UNITED STATES NUCLEAR REGULATORY COMMISSION

APPLICATION FOR AMENDMENT
OF
FACILITY OPERATING LICENSE
DPR-44

APPLICATION FOR AMENDMENT
OF
FACILITY OPERATING LICENSE
DPR-44

Philadelphia Electric Company, Licensee under Facility Operating License DPR-44 for Peach Bottom Atomic Power Station Unit No. 2, hereby requests that the Technical Specifications incorporated in Appendix A of the Operating License be amended by revising certain sections as indicated by a vertical bar in the margin of attached pages iv, 1, 3, 4, 7, 10, 11, 15, 18, 19, 20, 21, 31, 33, 35, 37, 40, 54, 73, 74, 91, 92, 108, 111, 115, 119, 120, 122, 133a, 133c, 140, 140a, 140b, 140c, 140d, 140e, 142b, 142e, 144, 152a, 157, 241, and by adding pages 142g and 142h.

Figure 3.5.1.F Maximum Average Planar Linear Heat Generation Rate Versus Planar Average Exposure

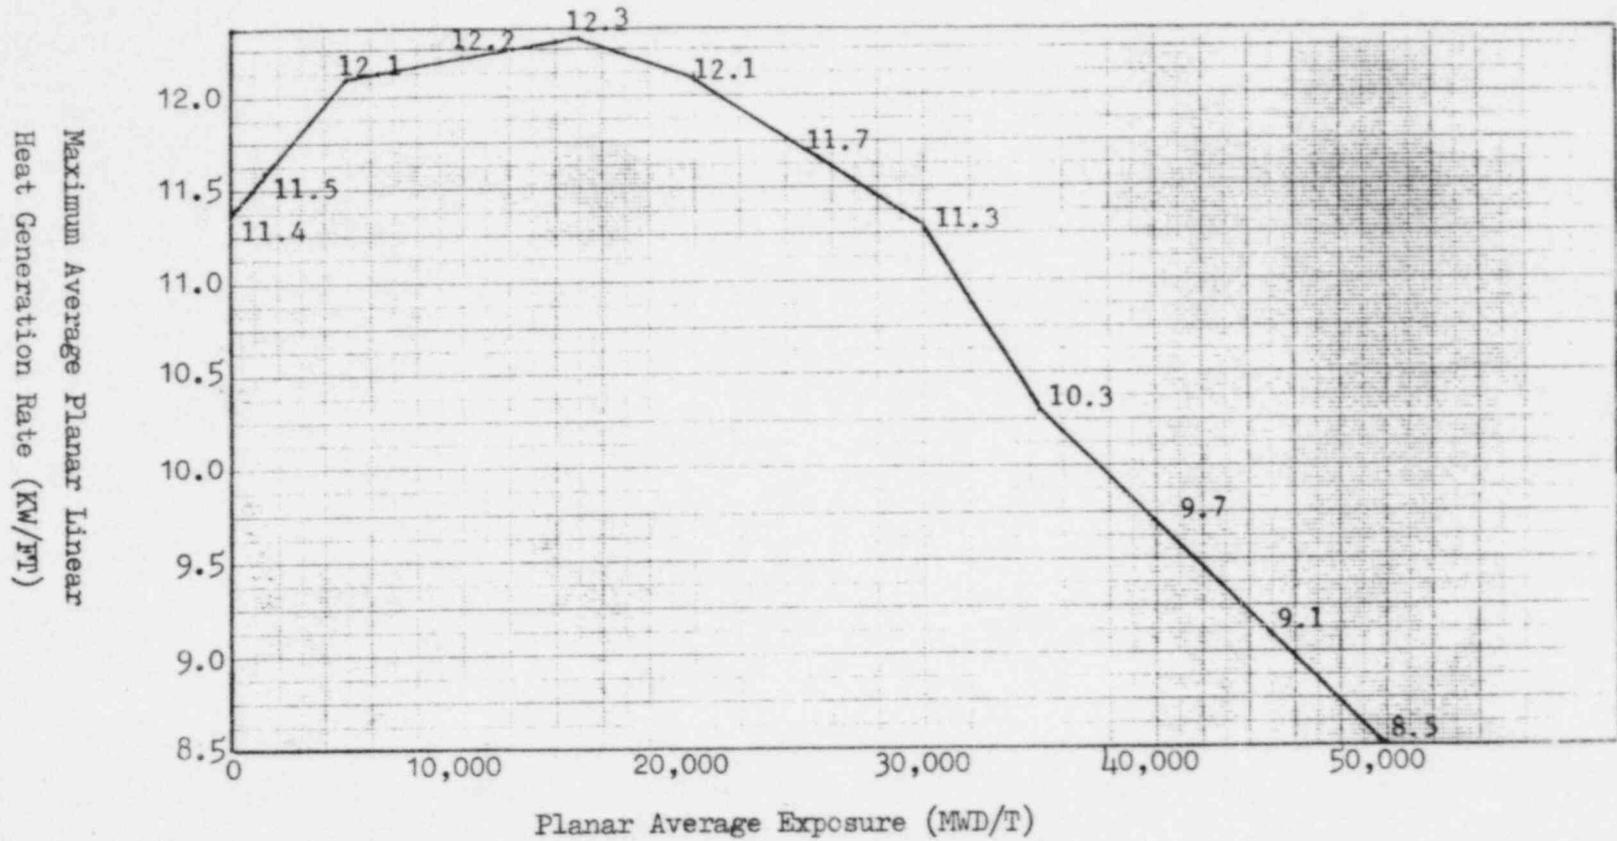
The changes requested herein provide for the extended operation of the 4 Lead Test Assemblies (LTA). The extended operation is necessary to obtain information for a program which is directed toward improving uranium utilization.

The calculational procedure used to establish the APLHGR shown on Figures 3.5.1.C, D, F, G, H, and I is based on a loss-of-coolant accident analysis. The analysis was performed using General Electric (GE) calculational models which are consistent with the requirements of Appendix K to 10 CFR Part 50. A complete discussion of each code employed in the analysis is presented in Reference 4. Input and model changes in the Peach Bottom loss-of-coolant analysis which are different from the previous analyses performed with Reference 4 are described in detail in Reference 8. These changes to the analysis include: (1) consideration of the counter current flow limiting (CCFL) effect, (2) corrected code inputs, and (3) the effect of drilling alternate flow paths in the bundle lower tie plate.

Figure 3.5.1.H Maximum Average Planar Linear Heat Generation Rate Versus Planar Average Exposure

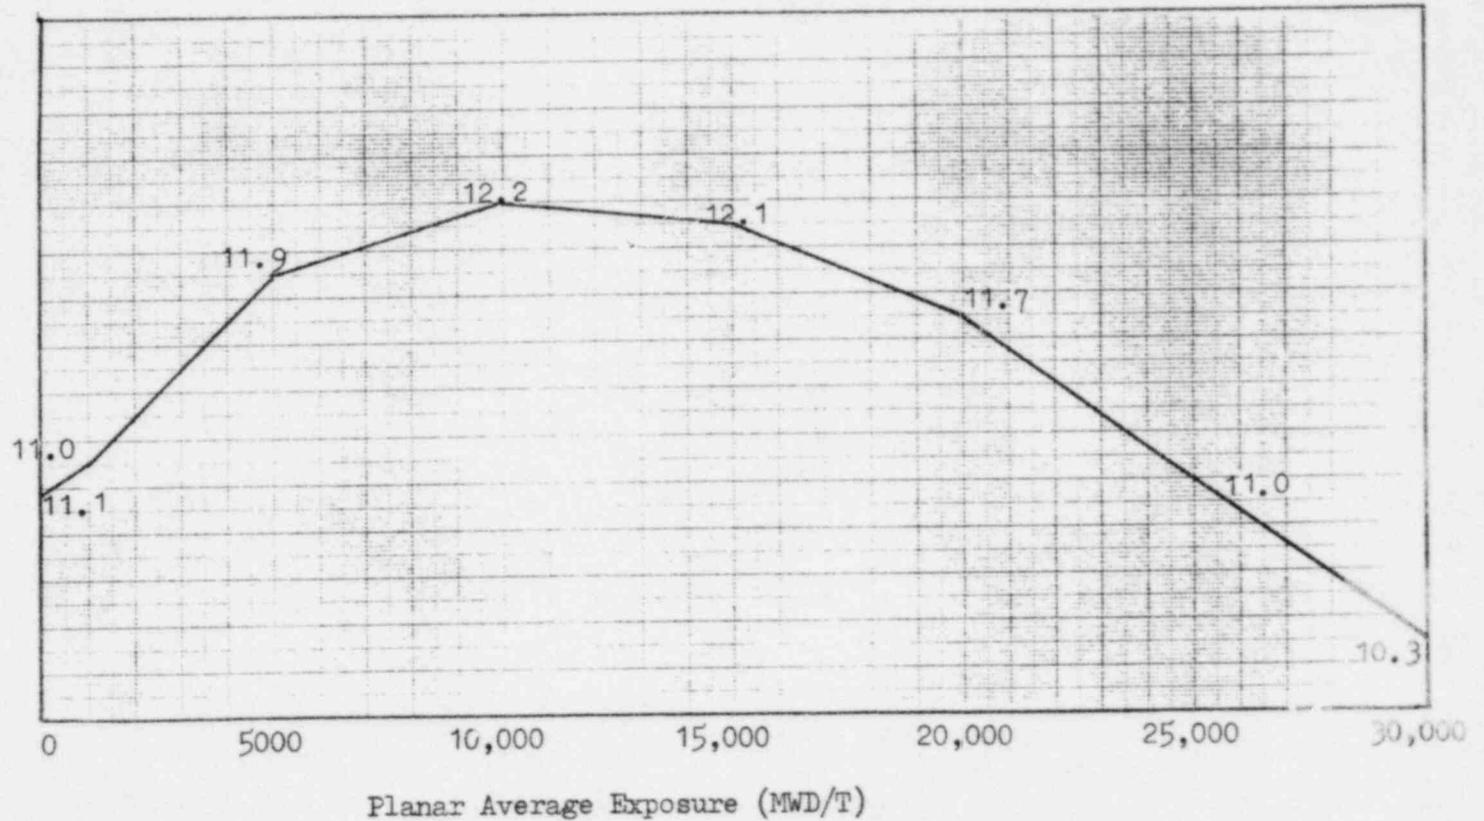
The changes requested herein would permit the loading of the prepressurized retrofit 8X8 fuel design. A safety evaluation report concerning the use of the prepressurized retrofit 8X8 fuel is provided by General Electric document entitled "Generic Reload Fuel Application" (NEDE-24011-P-A),
